Department: Service
 Section: Engine
 Model(s): GH7
 Model Year(s): 2011, 2012 & 2013
 Effective Date: February 26, 2018
 Form #: TB EN-60
 Rev #: N/A
 Supersedes: N/A

SUBJECT: Exhaust Gas Recirculation (EGR) Differential Pressure Sensor

Purpose: This is the permanent solution to replace EGR pressure sensors from a Kavlico-made to a Sensata-made.

Installation of New Pressure Sensor and Harness:

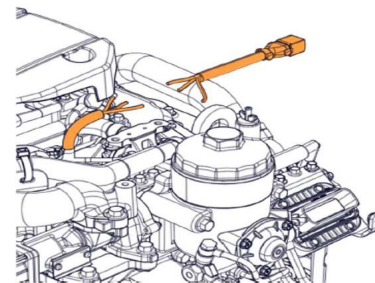
Install New Pressure Sensor first. Then measure before cutting existing harness to ensure adequate length for splice.

Cut the Engine harness as shown and Install the New harness furnished in the kit following the color code below.

<u>New harness</u>	<u>Engine harness</u>
Brown >>>>>>>>>>>>>>>>>>>>>>	Brown
Yellow >>>>>>>>>>>>>>>>>>>>>>	Brown / white strip
Green >>>>>>>>>>>>>>>>>>>>>>	Green / white strip
